**KNOXVILLE HISTORIC ZONING COMMISSION
STAFF REPORT - CERTIFICATE OF APPROPRIATENESS APPLICATION**

PROPERTY ADDRESS: 116 E Jackson Ave 37902

FILE NO.: 9-H-17-HZ

► **DESCRIPTION OF WORK:**

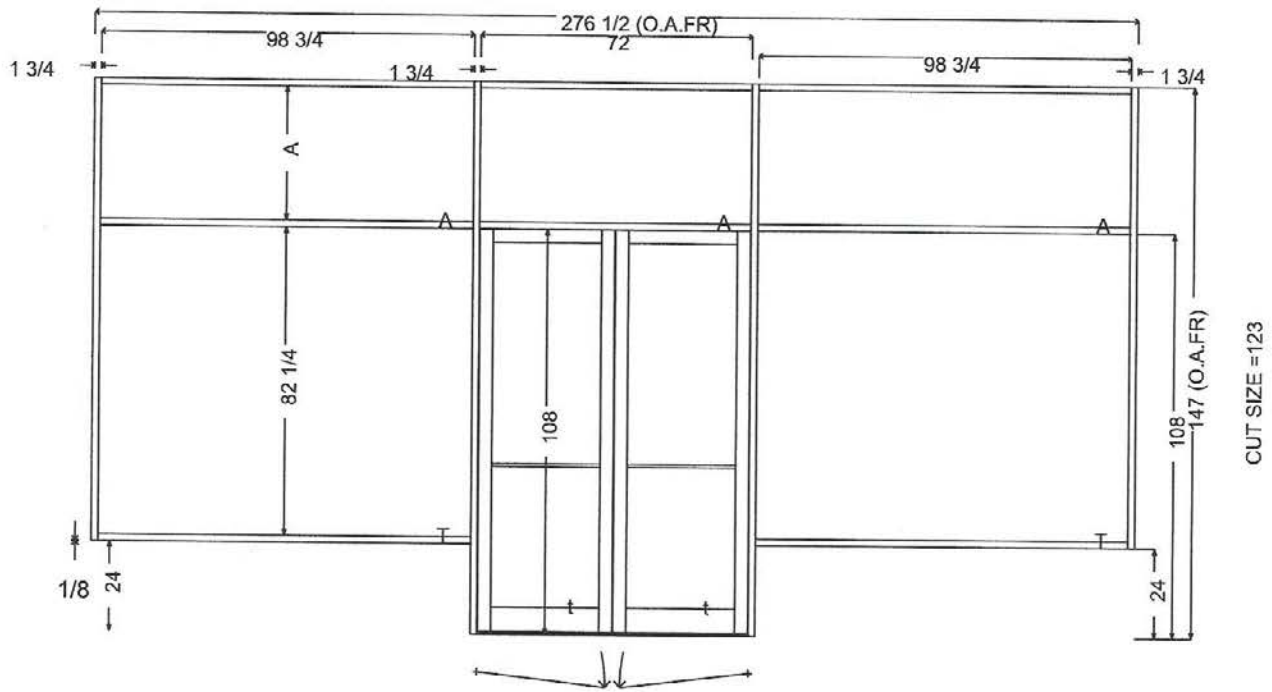
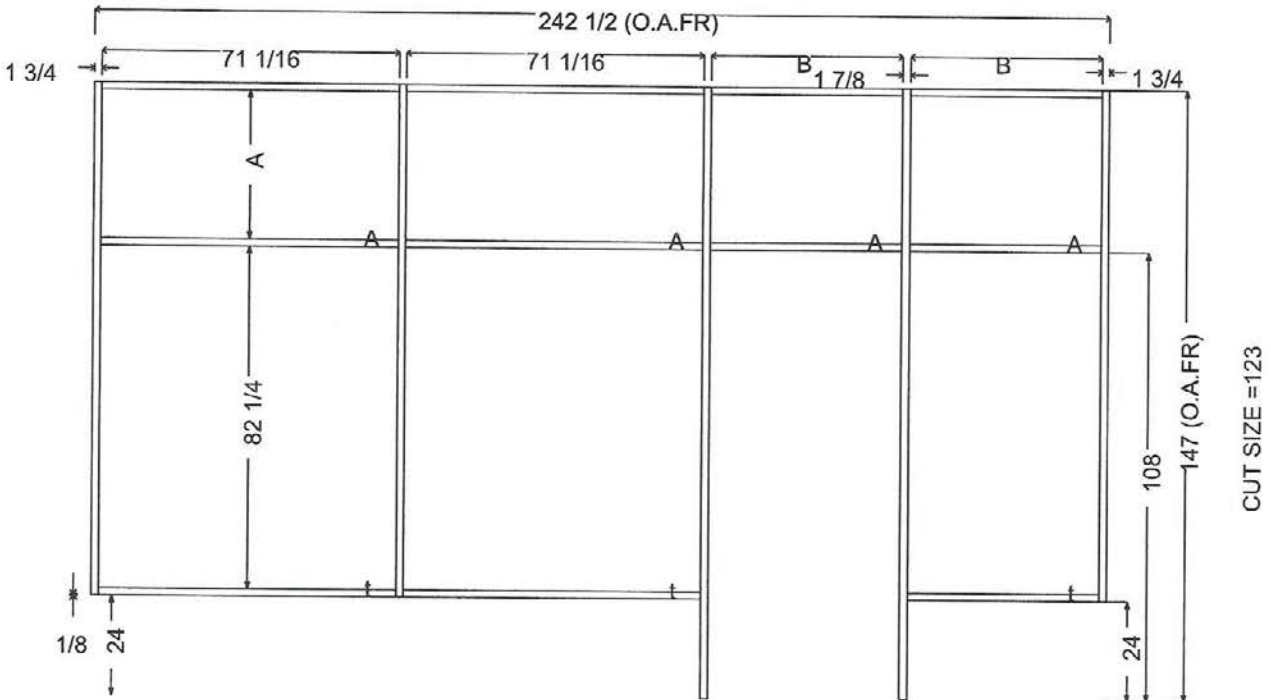
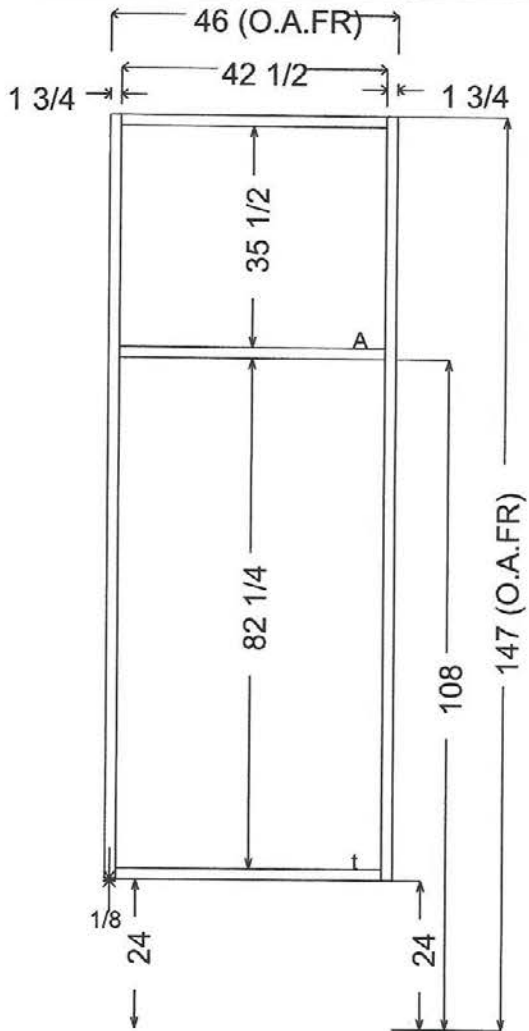
5. The proposed metal materials for framing for the large storefront windows and transoms, and wood for the bulkhead and entry door frame are appropriate materials and appropriately scaled based on the specifications.

6. The scale and sectional divisions of the proposed storefront are appropriately proportional and scaled based on designs for similar-era buildings.

Approval of the proposal. Specific wood-framed door design to be approved by staff if requested to deviate from submitted renderings.

Evidence of cut beam against facade

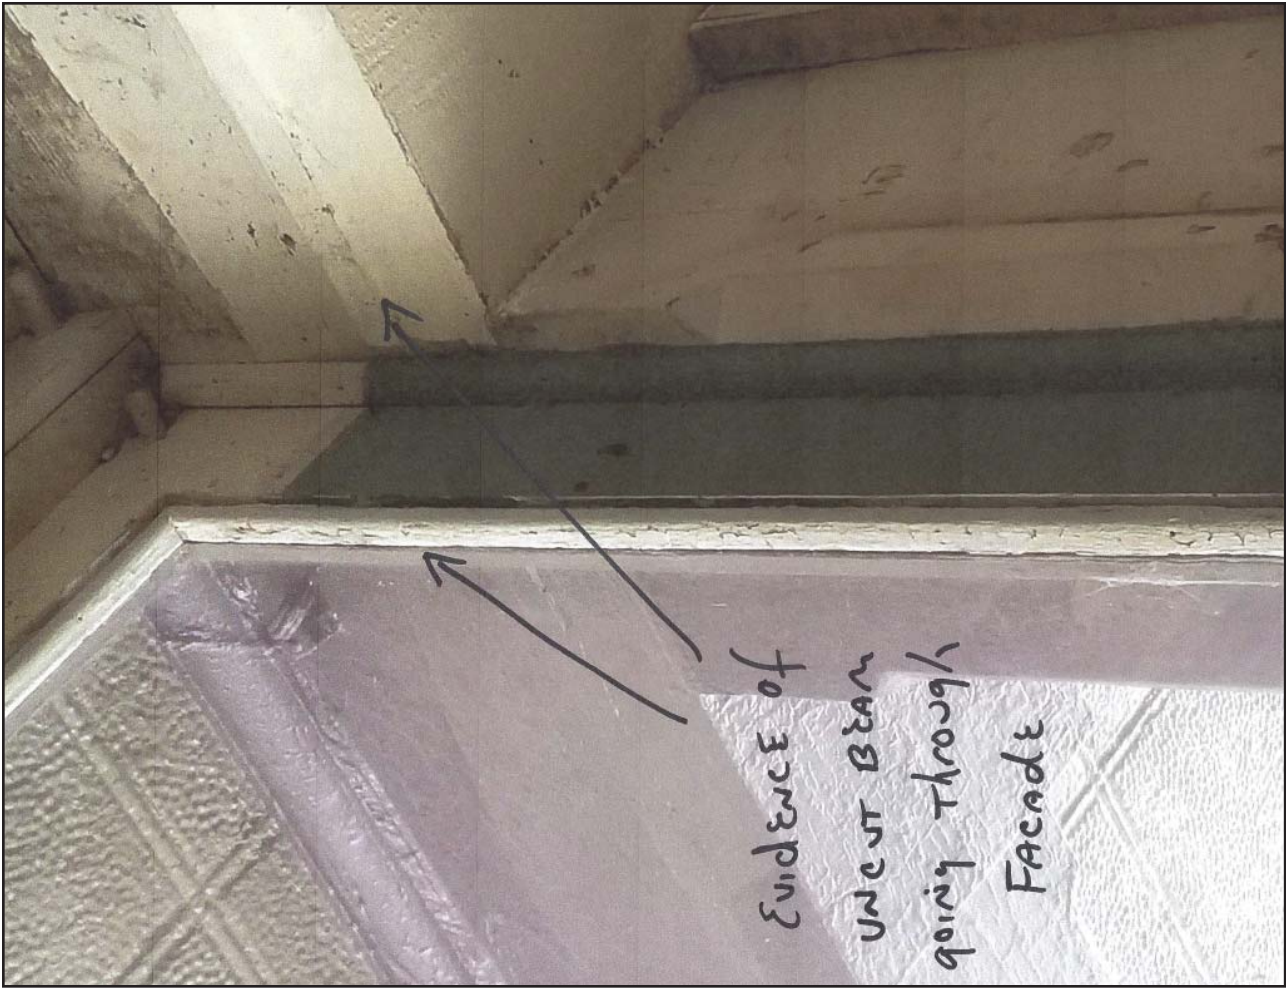
- Evidence of uncut ceiling-beam going through the façade
 - Evidence of cut ceiling-beam against façade
3. There is also photographic evidence of the storefront configuration of similar-era buildings in the area.

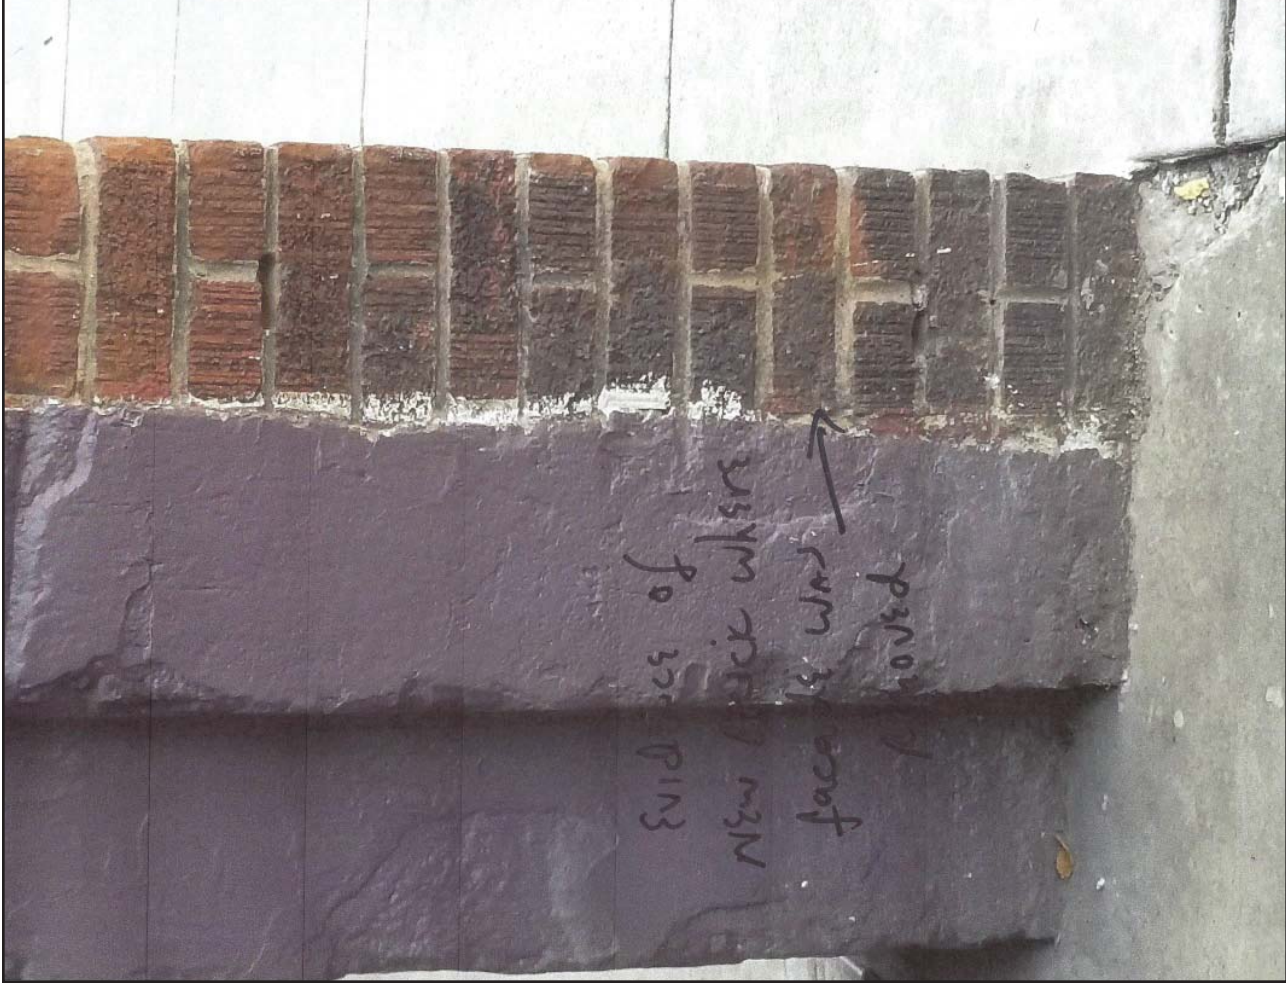
- Evidence of more recent infill brick where façade was removed
 - Evidence of remaining early brick at original street-face facade
 - Evidence of more recent poured concrete on floor

- Non-historic bulkhead on recessed facade
 - Evidence of new concrete poured as a base for recessed façade
 - Added column for cut ceiling-beam support
